Re: **PETITION NO. 1372** – Derby Fuel Cell, LLC petition for a declaratory ruling, pursuant to Connecticut General Statutes §4-176 and §16-50k, for the proposed construction, maintenance and operation of a 14.0-megawatt fuel cell facility and associated equipment to be located at 200 Roosevelt Drive, Derby, Connecticut.

Pursuant to the Council's request dated March 27, 2020, enclosed on behalf of Derby Fuel Cell, LLC (the "Company"), is an electronic copy of the Company's responses to the Council's Set Two questions 5-7 in the above-referenced matter.

Interrogatory CSC-5

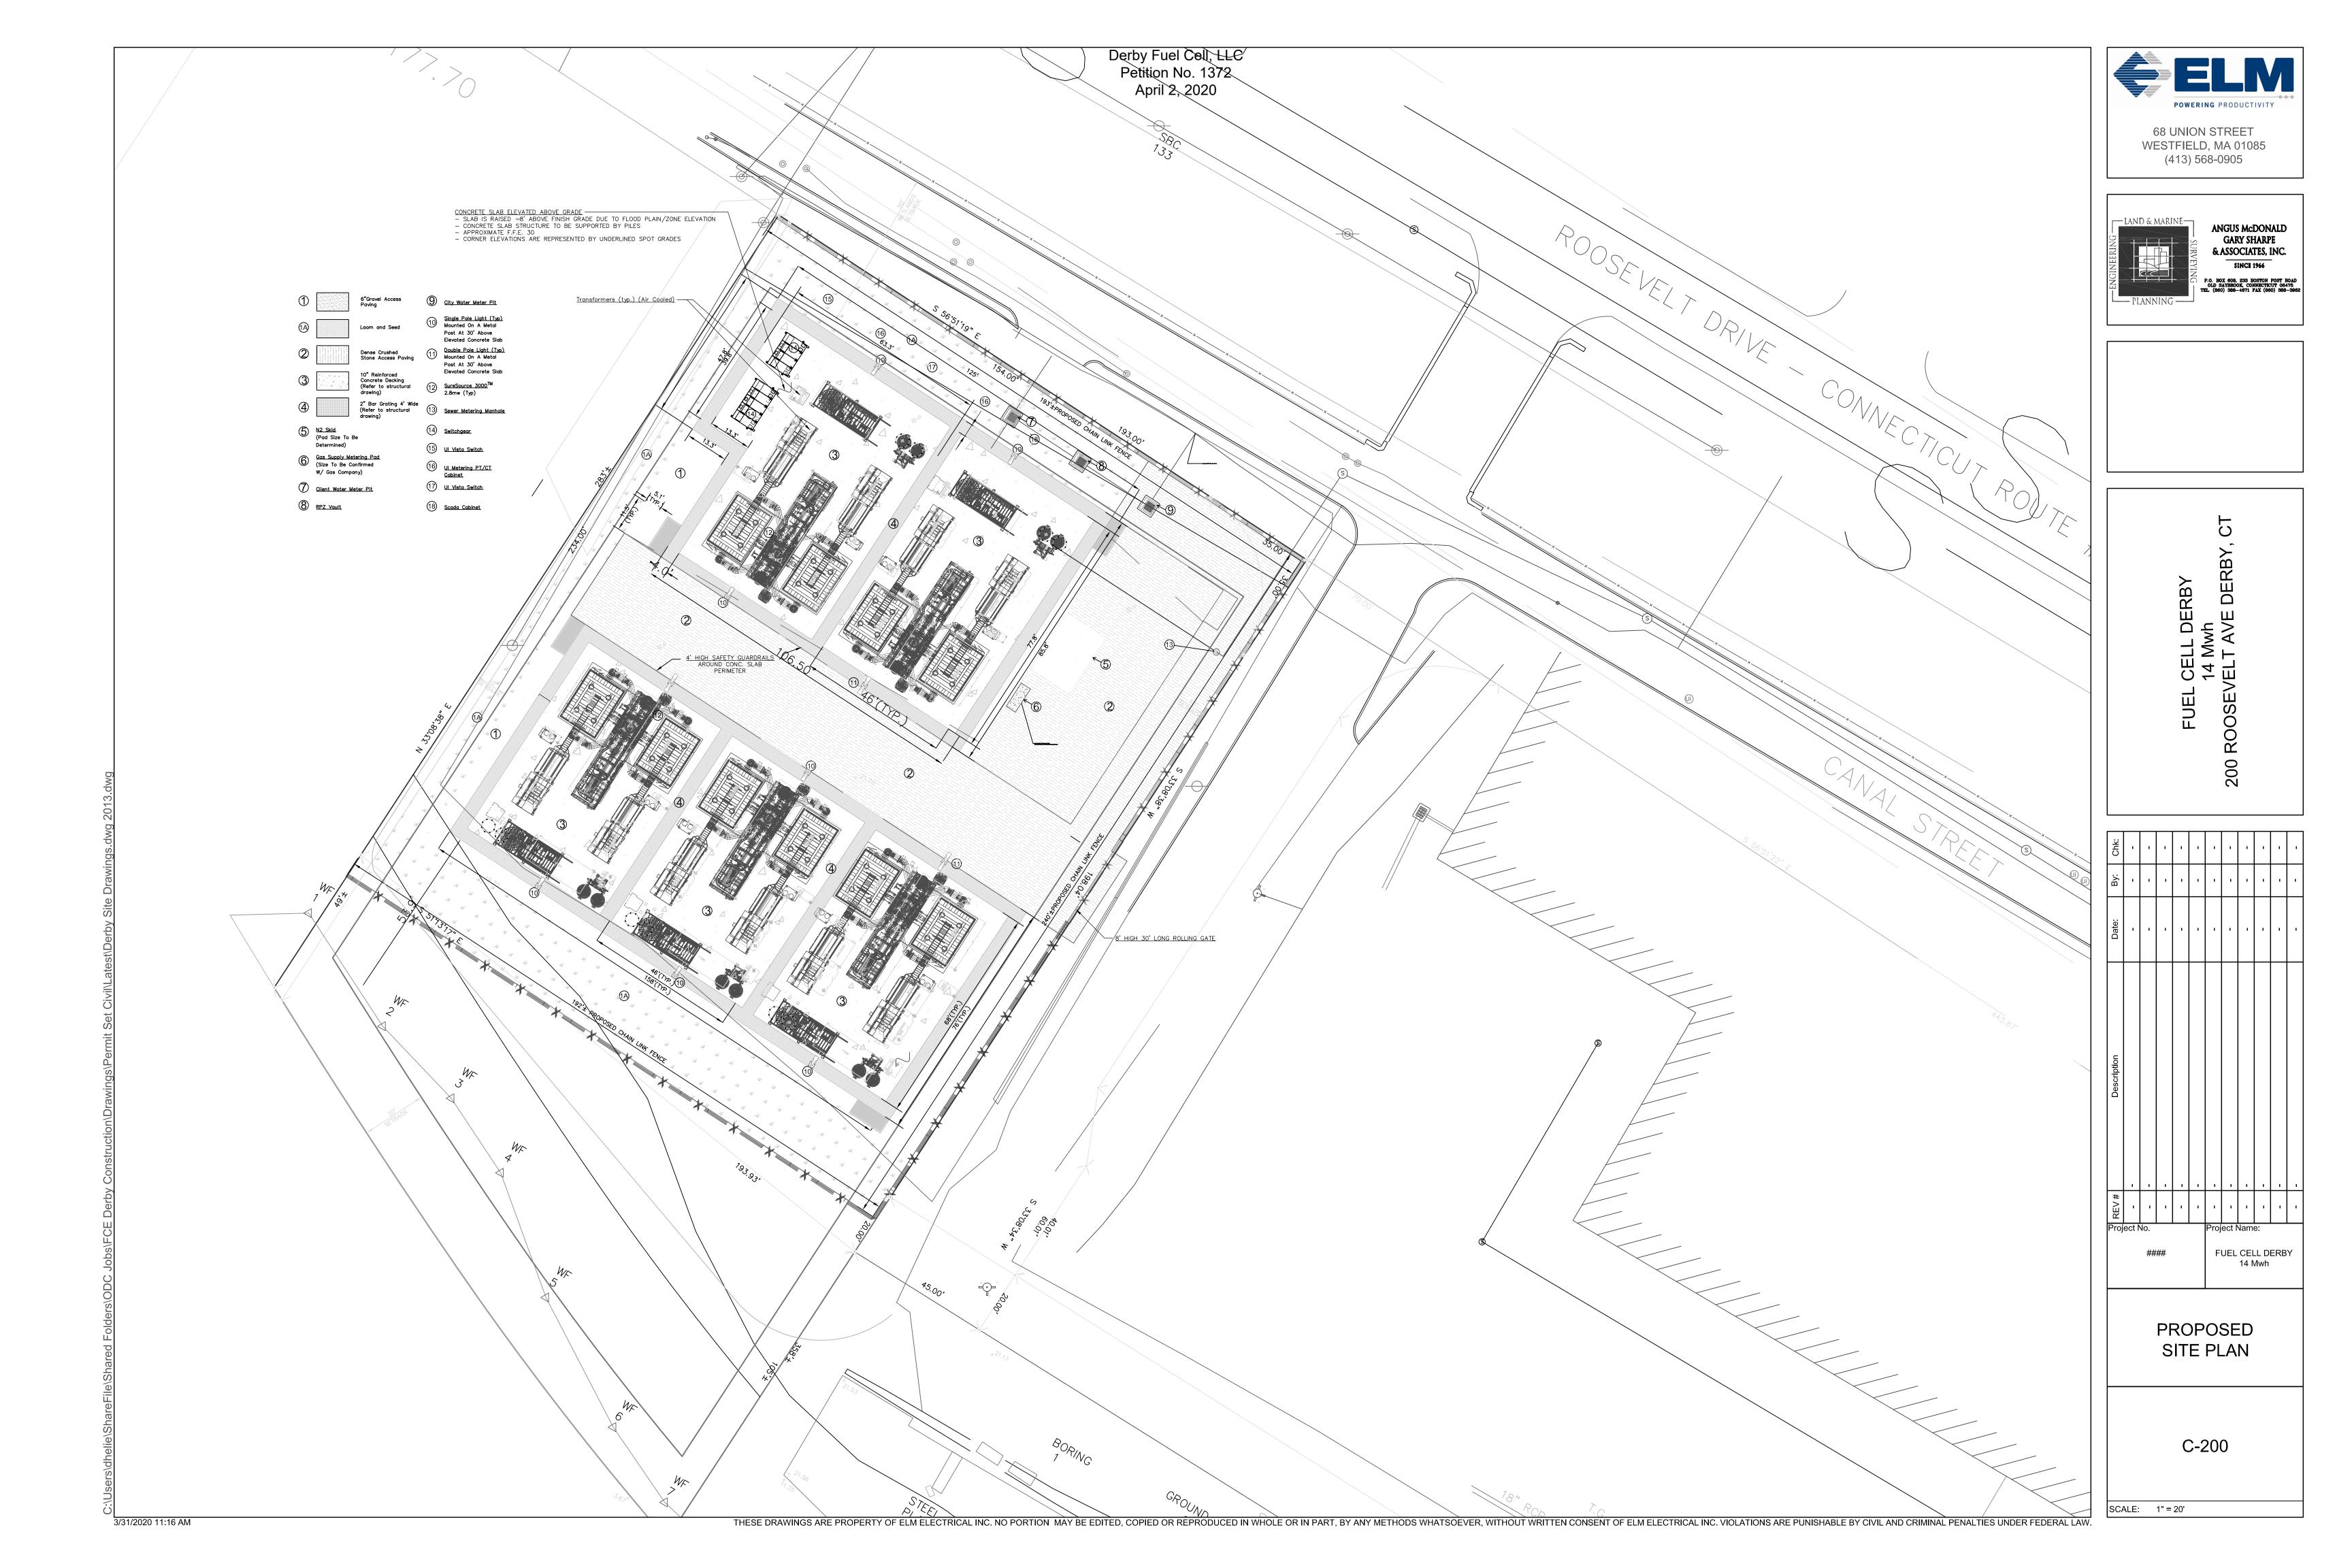
Condition 1a of the Connecticut Siting Council's (Council) July 19, 2019 declaratory ruling (Declaratory Ruling) requires that the Development and Management Plan (D&M Plan) include "A final site plan including, but not limited to, fuel cell units, related equipment, transformer locations (both dry and insulating fluid-filled) with containment measures as necessary, perimeter fence, concrete pads..." Please identify the transformer locations on the site plan and indicate if any containment measures are necessary for any insulating fluid-filled transformers, if applicable.

Q-CSC-6: Referencing the Site Development Plan, Sheet 2 of 3 submitted on March 25, 2020, is

there a fence on the north side of the compound, or is the compound only fenced on

three sides? If the fence is only on three sides, please explain why.

Q-CSC-7: Referencing the Site Development Plan, Sheet 2 of 3 submitted on March 25, 2020, the

compound dimension lines indicate "Proposed Chain Link Fence w/Razor Wire," and the note at the bottom of the drawing says "8' High Chain Link Fence (TYP) with Barbed Wire." Please clarify if the fence would have barbed wire, razor wire, or a combination

of both?

Only air-cooled (dry) transformers will be used at the Derby Fuel Cell Site. These transformers are not oil-filled and thus do not require any containment. An updated Site Plan is attached that specifically indicates the location of the transformers.

A-CSC-6: The substation has a separate, pre-existing fence on the northern side of the property.

The project will tie into this pre-existing fence, which is why a new fence is not shown

in that location.

A-CSC-7: For aesthetic reasons, barbed/razor wire on top of the fence was omitted from the Site

Development Plan. This call-out has been updated to reflect the final design

intent. Please see attached updated drawing.
